RE: Biological Mitigation Proposal ("Mitigated Ivanpah 3")
Ivanpah Solar Electric Generating System (07-AFC-5)

Biological Mitigation Proposal ("Mitigated Ivanpah 3")

Submitted to the
Bureau of Land Management and the
California Energy Commission

FIGURE 3-5
VIEWSHED MAP
 IVANPAH SOLAR ELECTRIC GENERATING SYSTEM

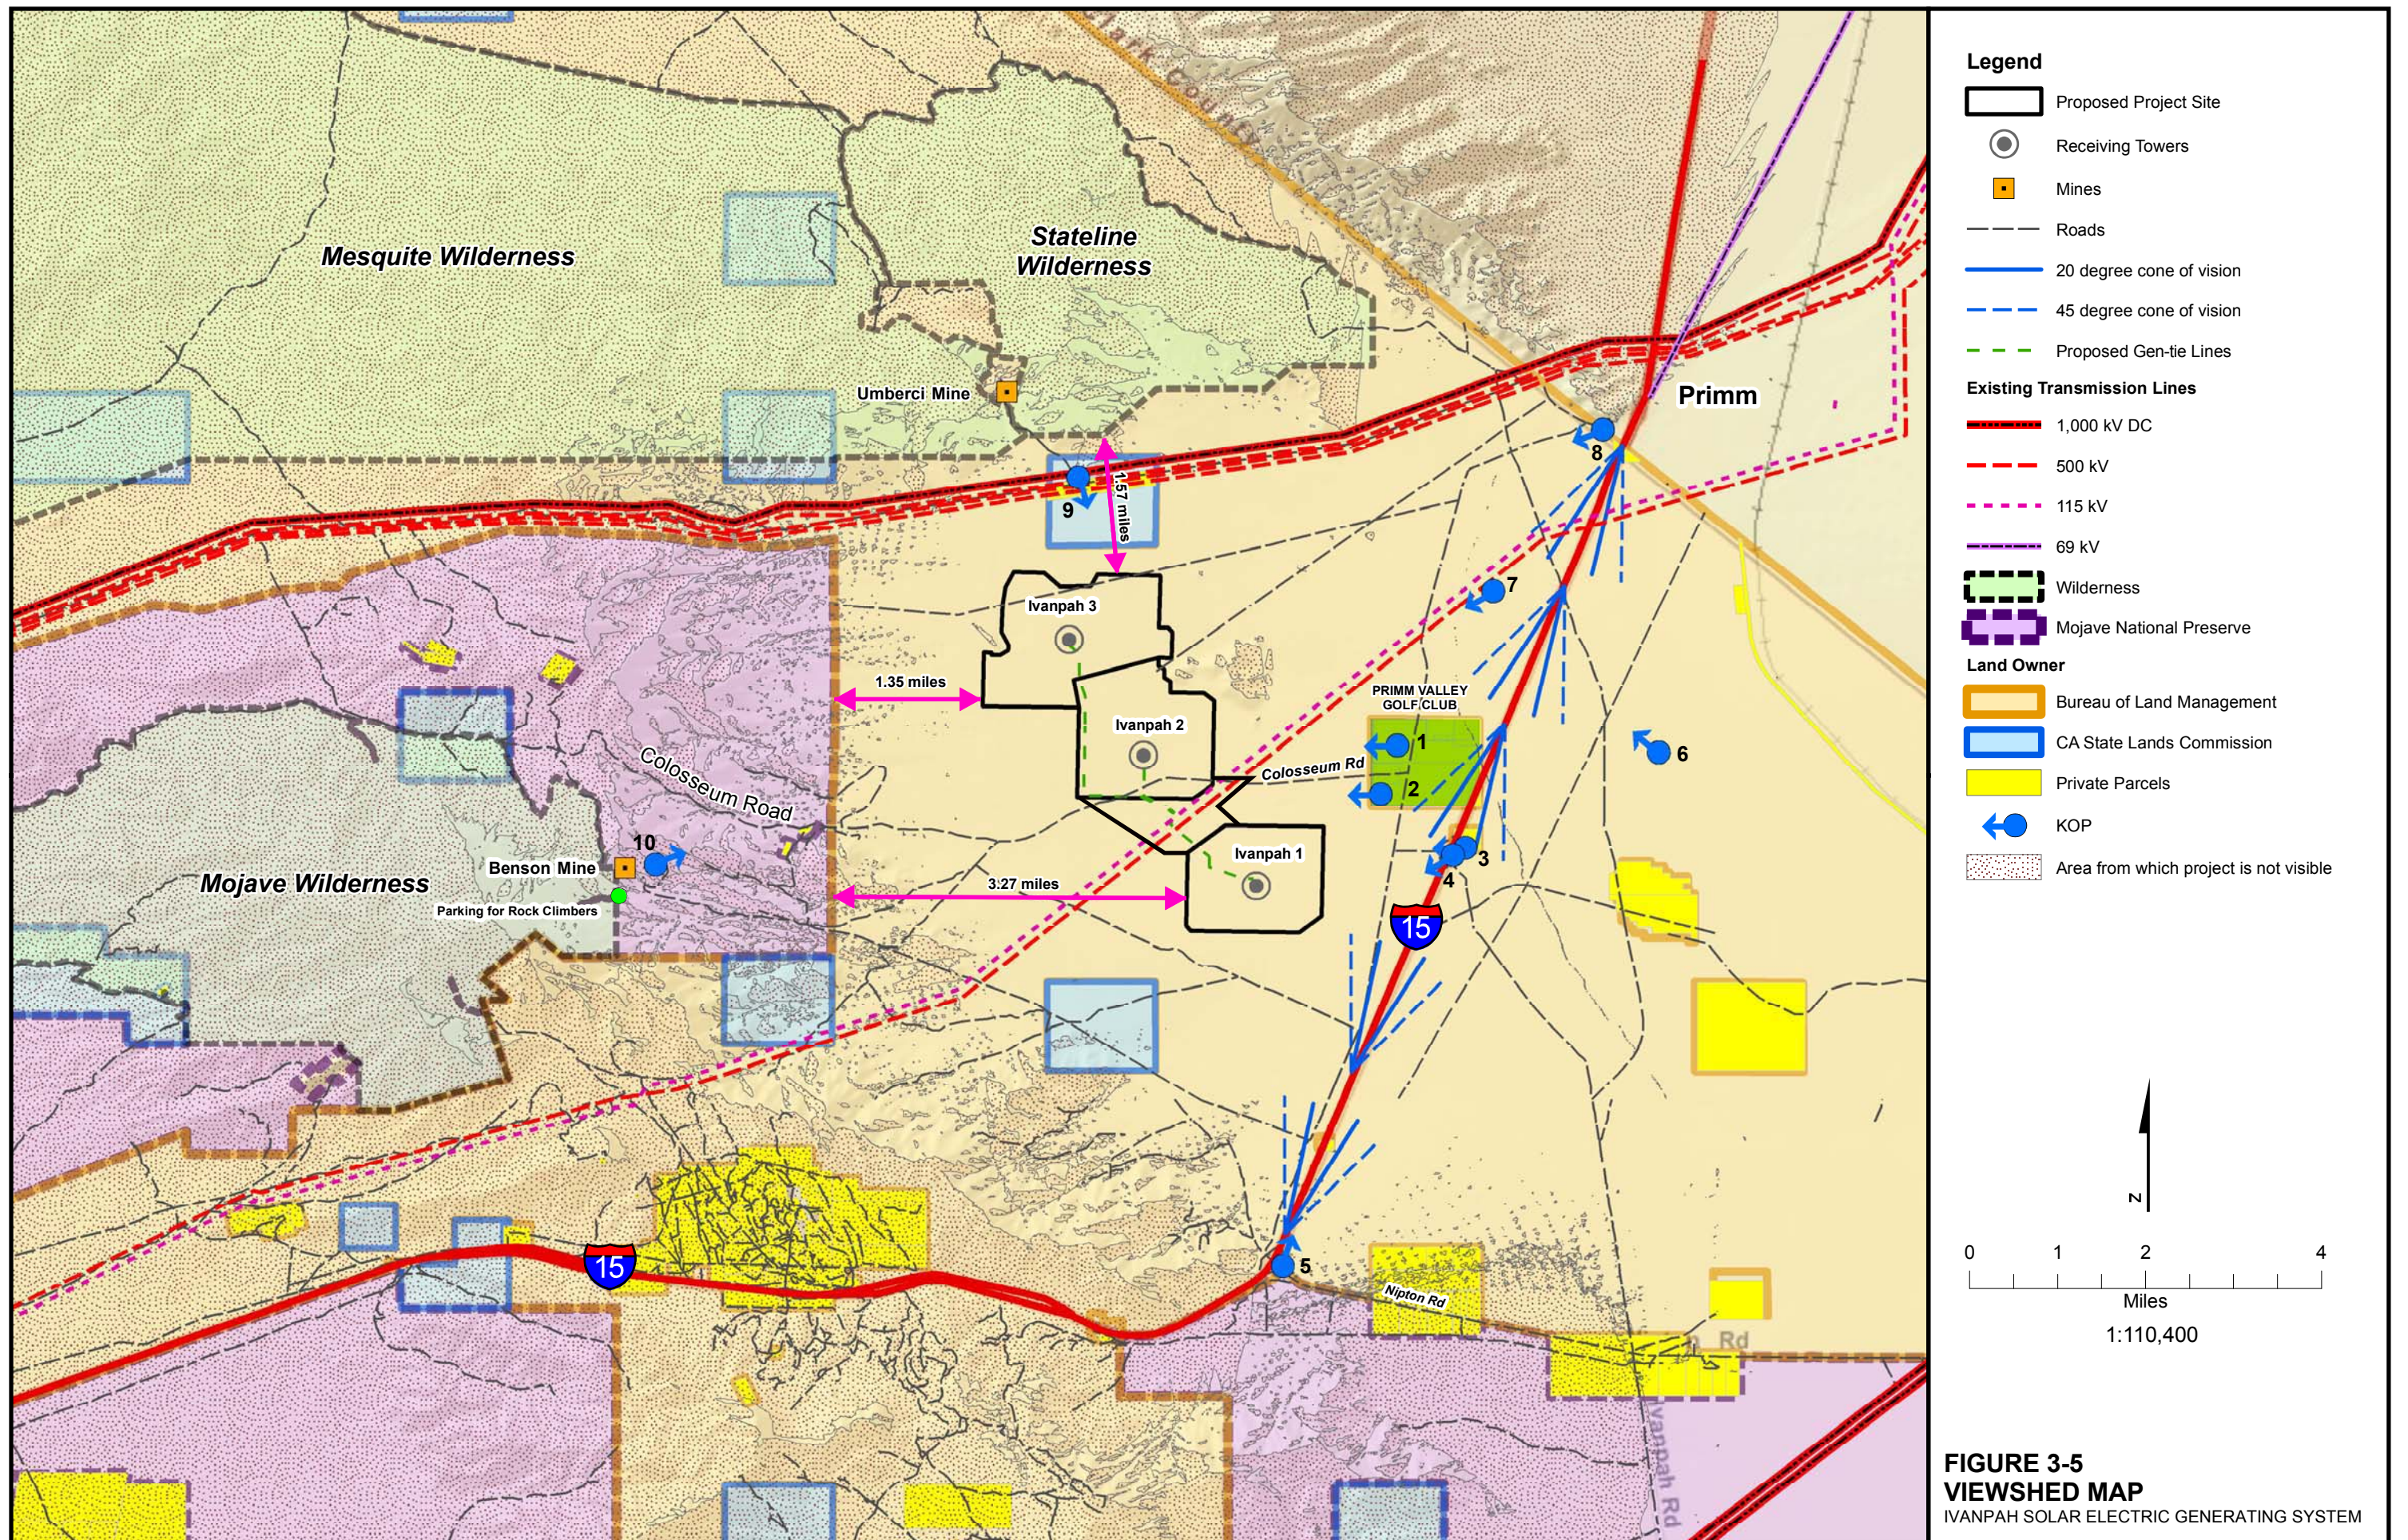
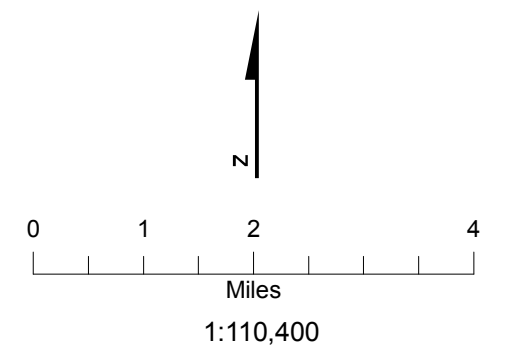
Figure 3-5 is a revised version of the viewshed map of the entire project area that depicts the new boundaries of Ivanpah 2 and 3; the change in the design of Ivanpah 3, with a single tower rather than five towers; and a revised delineation of the areas from which the scaled-back project would be visible. Figure 3-6 is a version of the viewshed analysis that focuses on the project site and its relationship to the Stateline Wilderness.

FIGURE 3-6
PROJECT VISIBILITY FROM
STATELINE WILDERNESS
 IVANPAH SOLAR ELECTRIC GENERATING SYSTEM

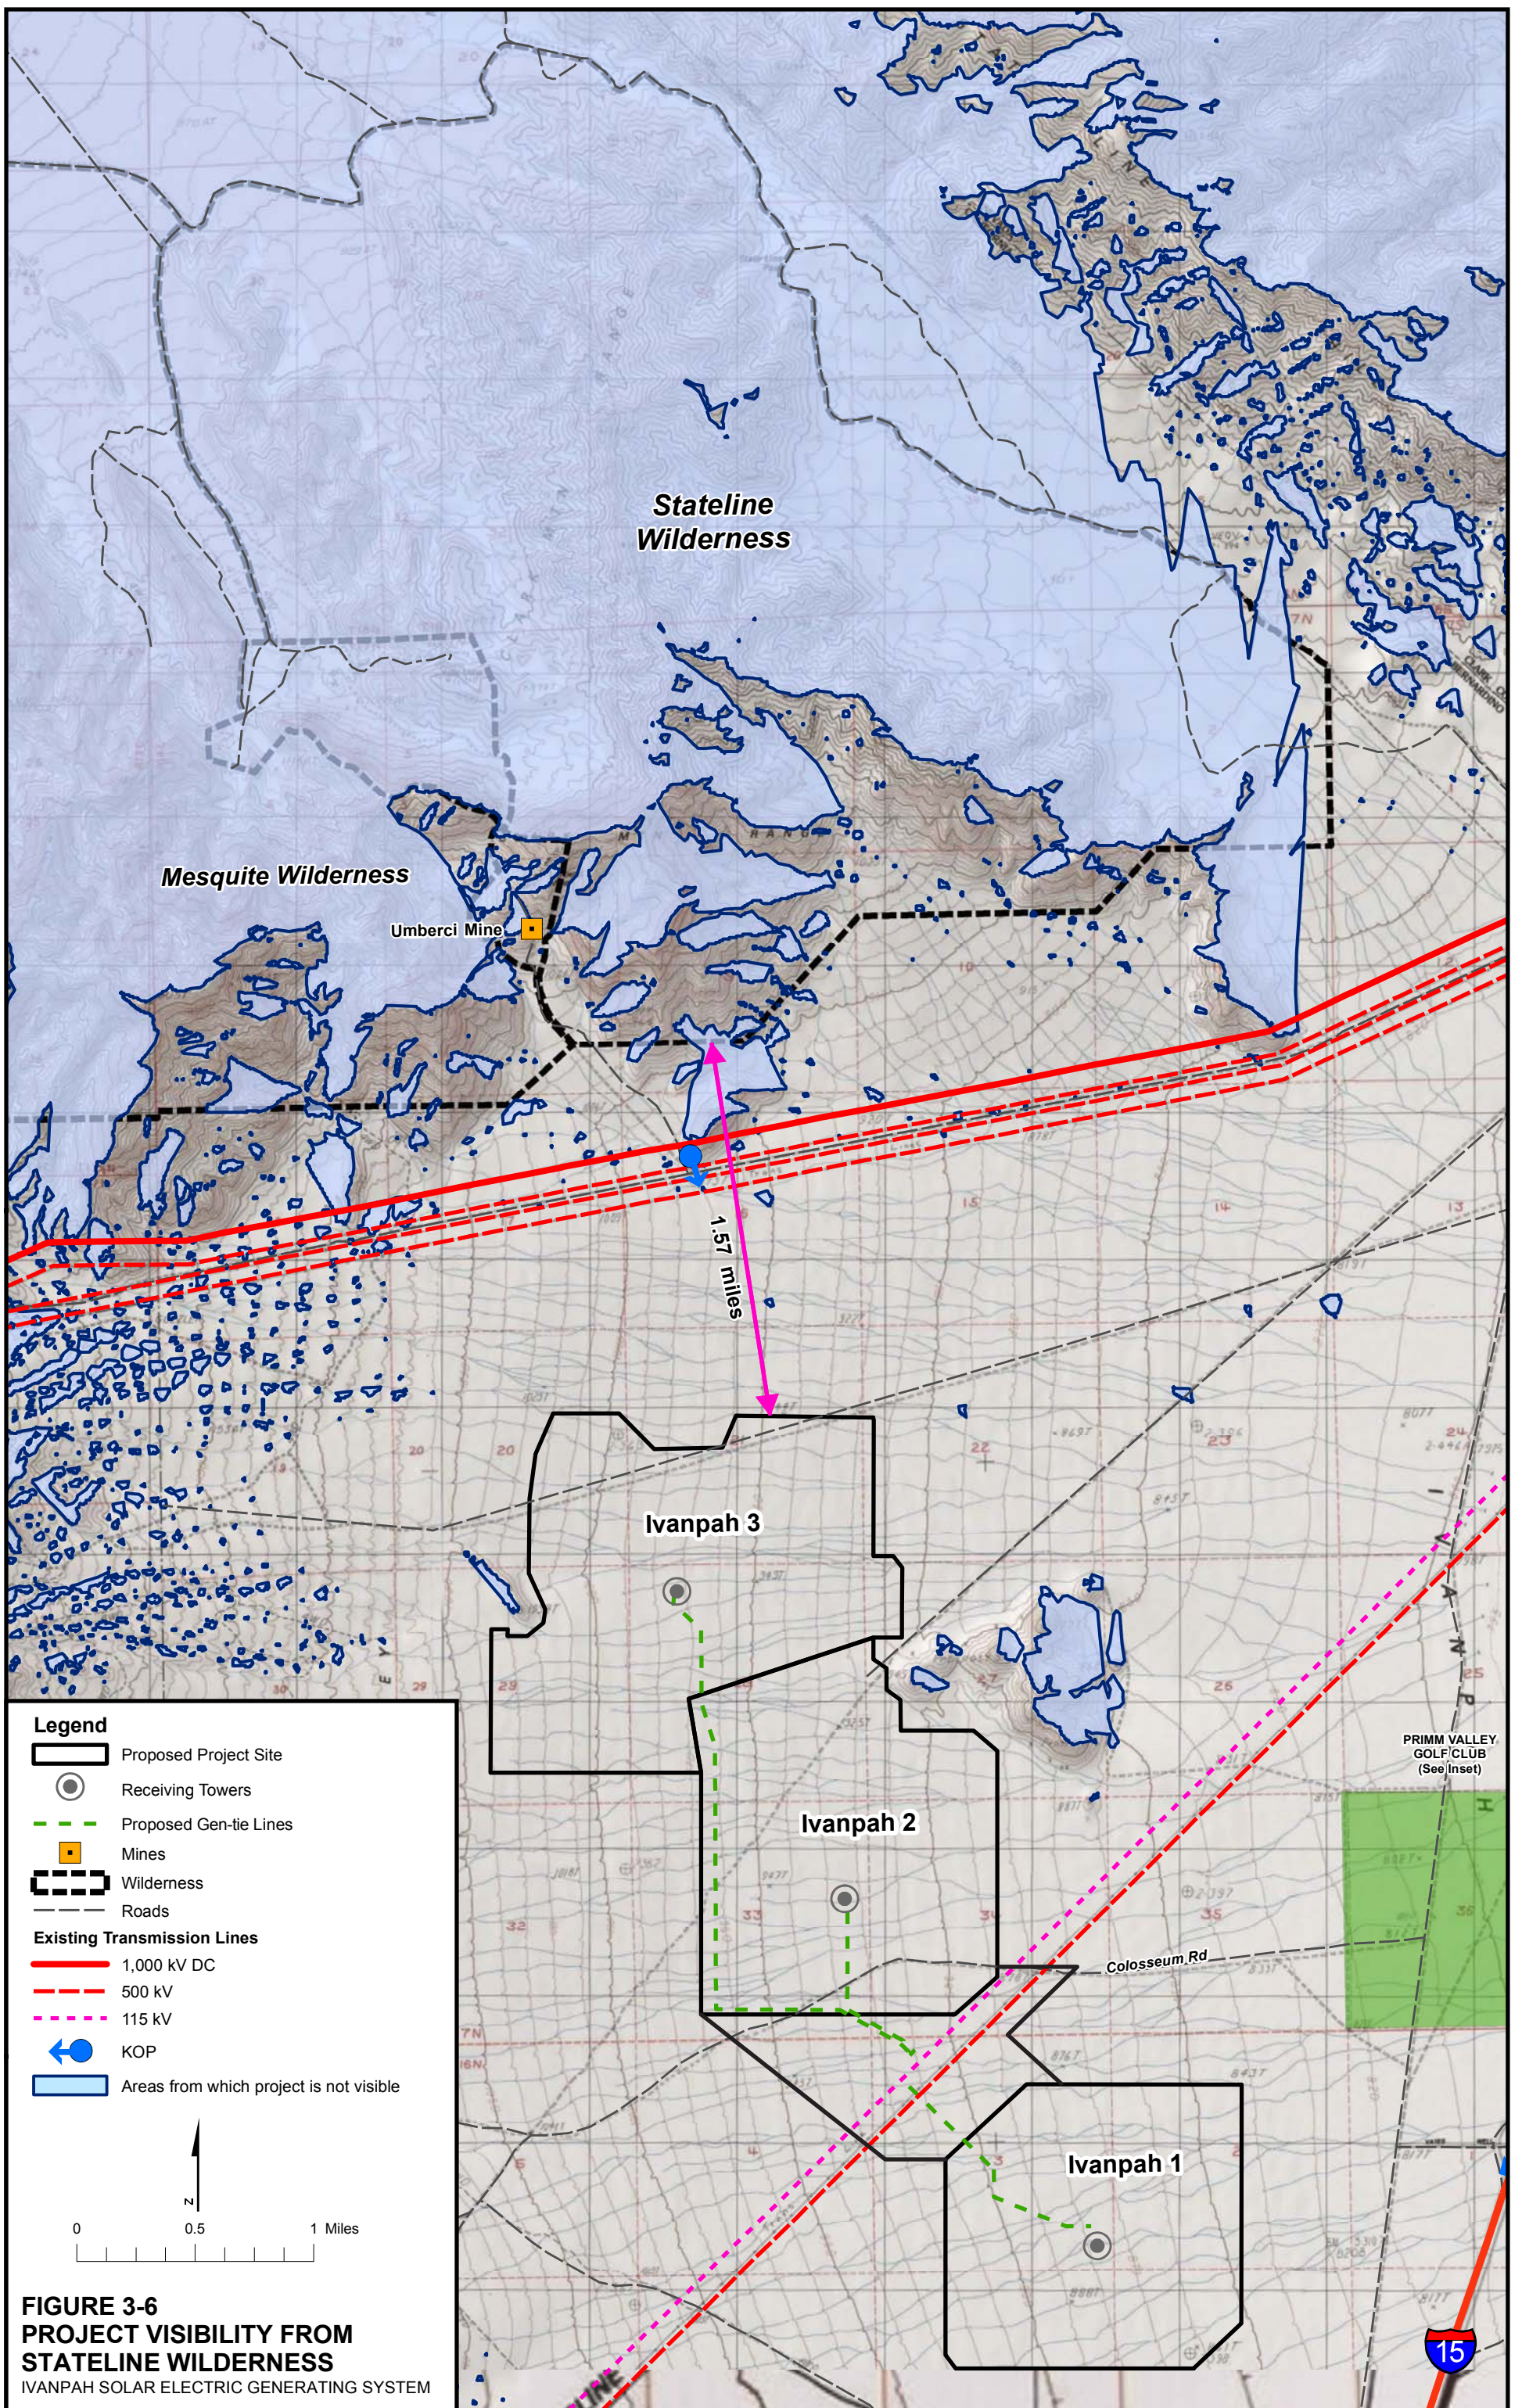
As review of Figure 3-6 indicates, the reduction of the area occupied by Ivanpah 3 would result in the northern boundary of Ivanpah 3 being pushed farther south, increasing the distance between it and the Stateline Wilderness to 1.57 miles at its closest point, with the closest power tower being more than 2 miles from the wilderness area boundary. With the reduction in the number of solar towers at Ivanpah 3 from five to one, the area from which the project has the potential to be visible would be less than under the present design. In fact, it would only be visible from less than 15 percent of the Stateline Wilderness. Review of Figure 3-5 indicates that because of the reduction in the area occupied by Ivanpah 3 on its northern and western sides, under the Mitigated Ivanpah 3 alternative, this unit at its closest point, would be 1.35 miles from the western boundary of the Mojave National Preserve; whereas, Ivanpah 1 would remain unchanged under the Mitigated Ivanpah 3 alternative, and would be located more than 3 miles from the Mojave National Preserve's eastern boundary.
